February 10, 2022

Product Change Notice - Protective rubber overmold added to In-Wall Slide-out motors

500:1

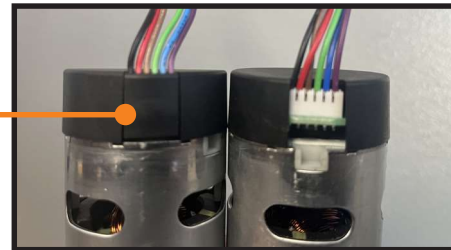
Please be advised, as part of continued improvement to overall motor durability, Lippert intends to add a protective rubber overmold to the 500:1 and 300:1 In-Wall Slide-out motors where the wire exits the motor.

Protective overmold
